PL6	Z&E	ED	-	ISSUED FOR FURTHER PLANNING ALTERATIONS
Mark	Date	By	Chk	App
Revision				
Drawing Status				
PLANNING ALTERATIONS 2021				
Job Title				
PROPOSED DEVELOPMENT AT KINGSWOOD BUSINESS PARK, BALDONNELL, DUBLIN 22				
Drawing Title				
DRAINAGE & WATERMAIN LAYOUT				
Architect/Client				
JMC VAN TRANS LTD				
KAVANAGH BURKE CONSULTING ENGINEERS				
Tel. 01-450 0694		Unit F3, Calmount Pk. Ballymount, Dublin 12.		
Fax. 01-426 4340				
Email: pkavanagh@kavanaghburke.ie				
Dr	ED	Checked	Approved	UB
Scales 1:500		Date August 2021		
Job No.	D1568	Drawing No.	D3	Rev. PL6

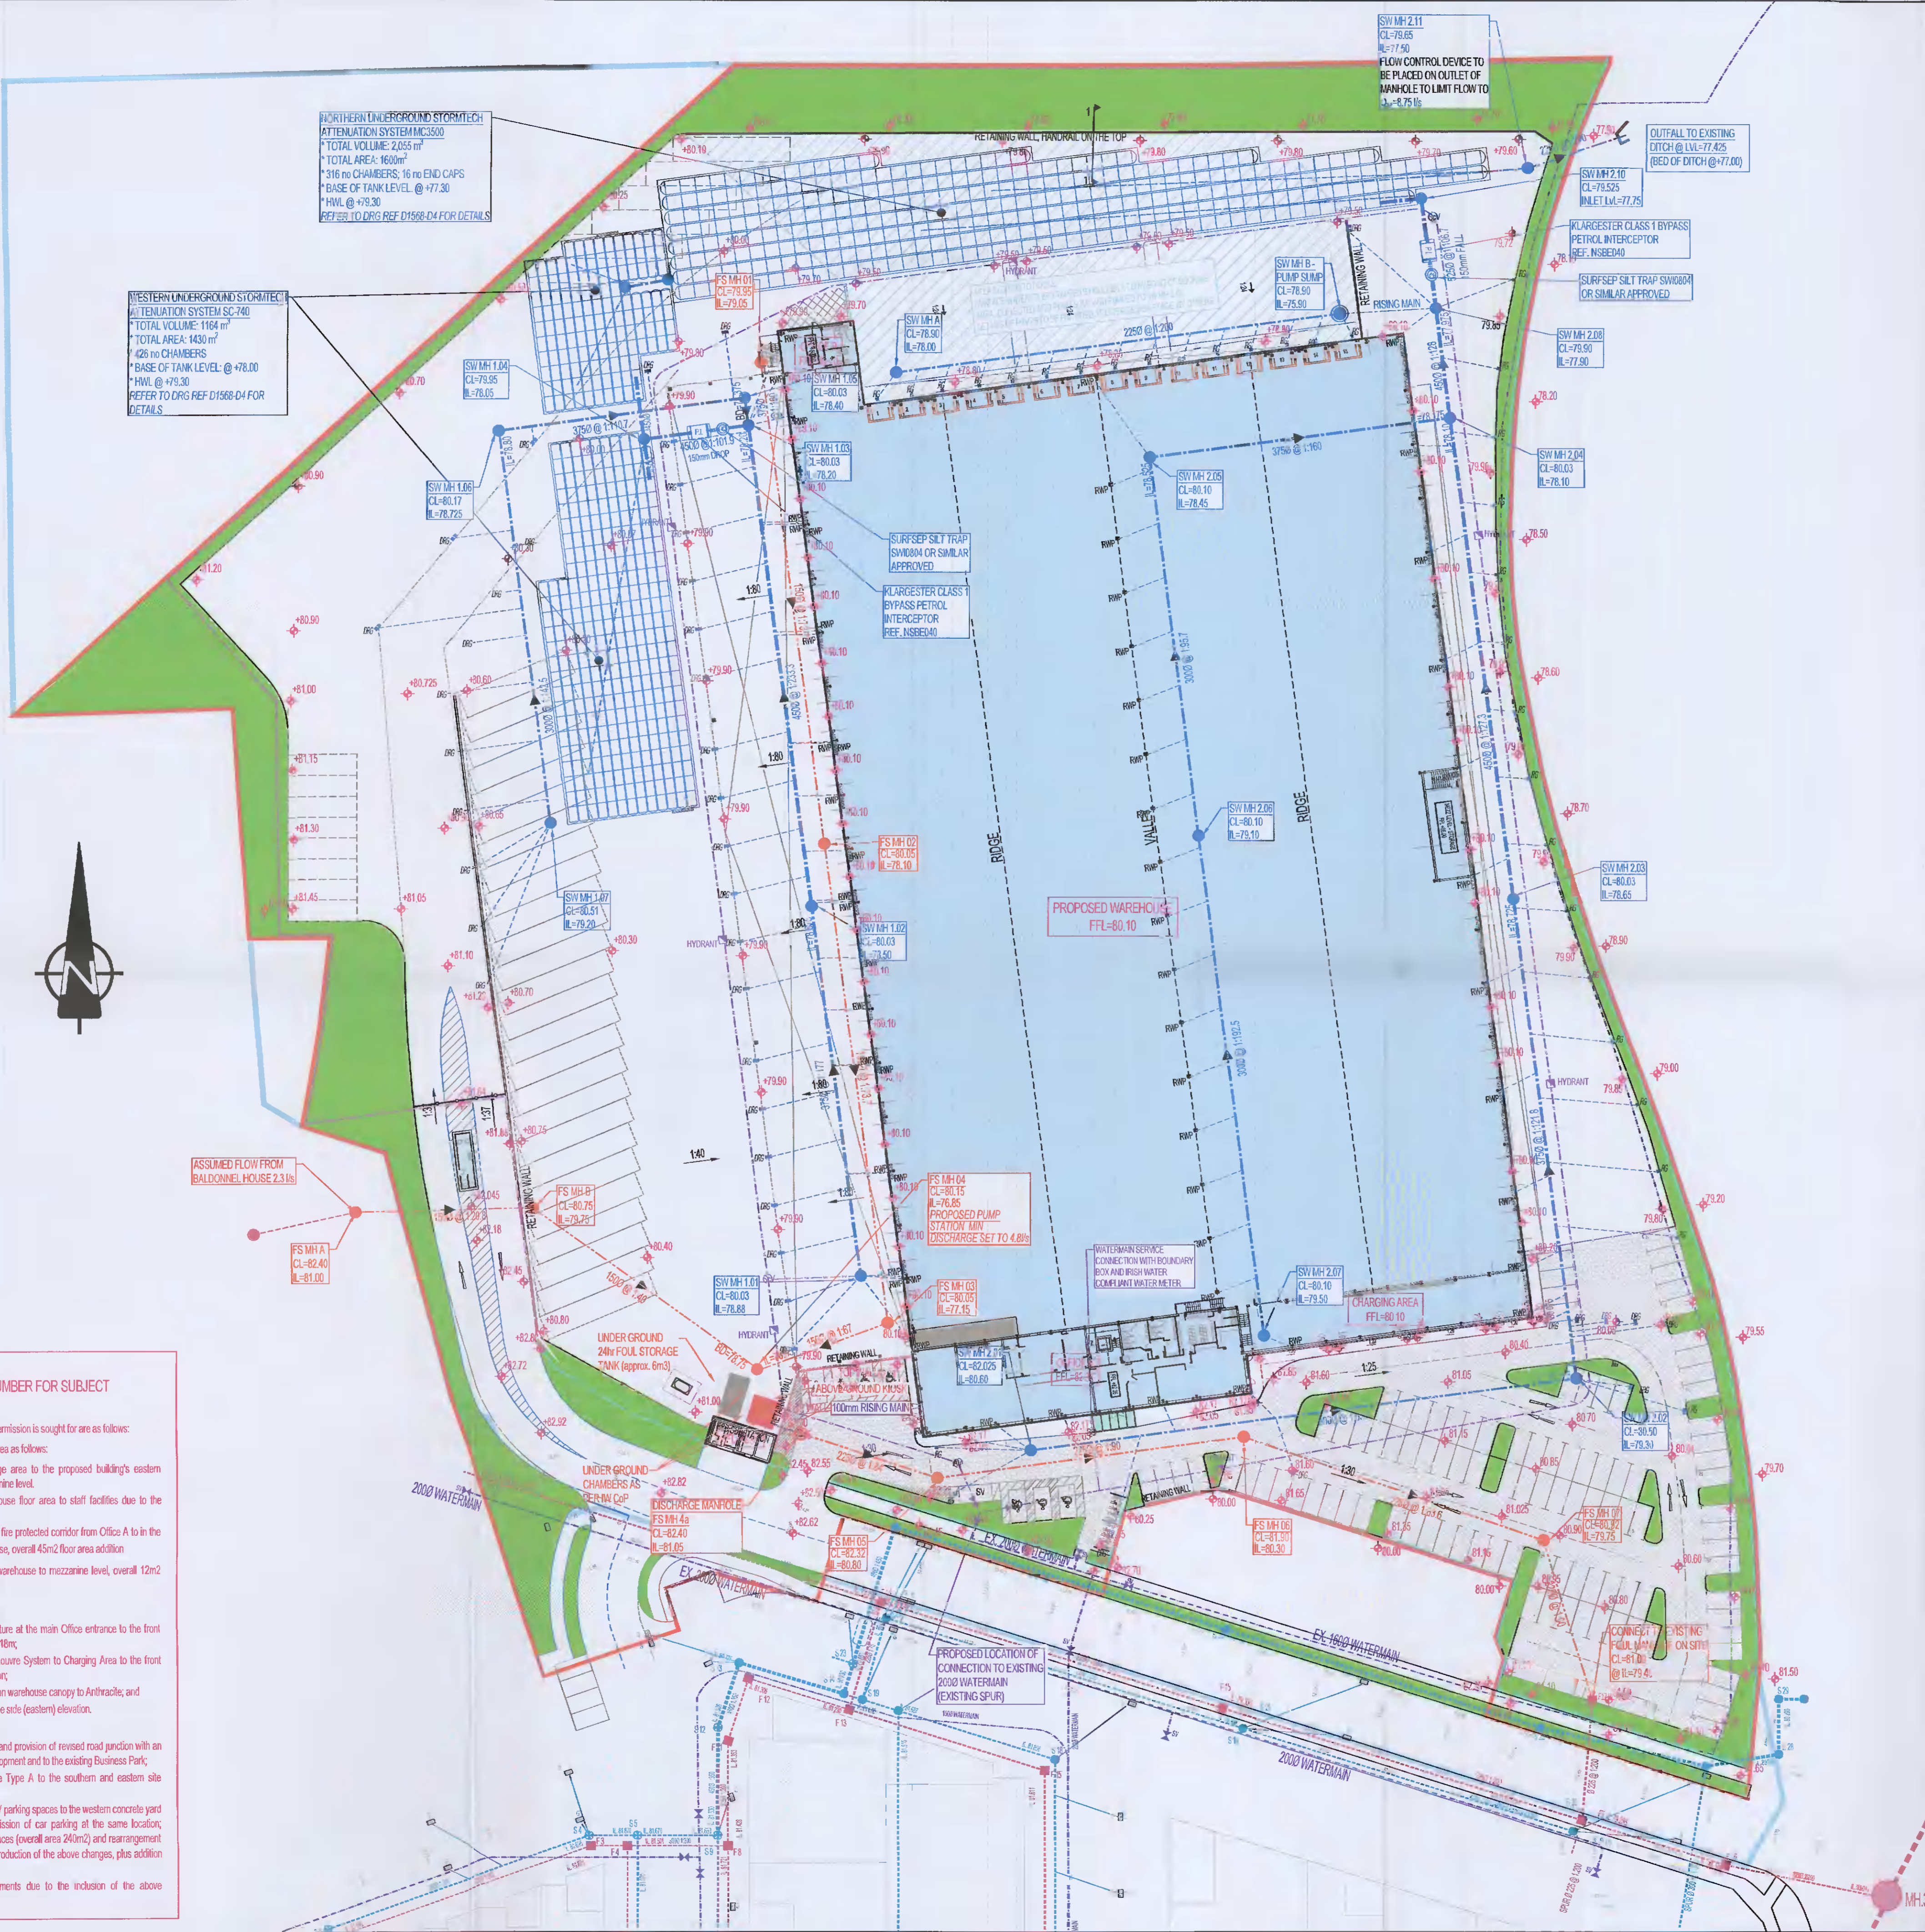
NOTE:
 THE DRAINAGE ARRANGEMENT FUNDAMENTALLY REMAIN THE SAME AS THE PREVIOUSLY GRANTED APPLICATION IN PRINCIPAL. ALBEIT FOUL SEWER DESIGN FLOWS REMAIN UNALTERED, THE NETWORK HAS BEEN REDESIGNED. SURFACE WATER DRAINAGE HAS BEEN ADJUSTED IN ACCORDANCE WITH THE NEW SITE PLAN. REFER TO THE ACCOMPANYING DRAINAGE DESIGN REPORT FOR REVISED CALCULATIONS.

- D. Associated drainage layout adjustments due to the inclusion of the above alterations.
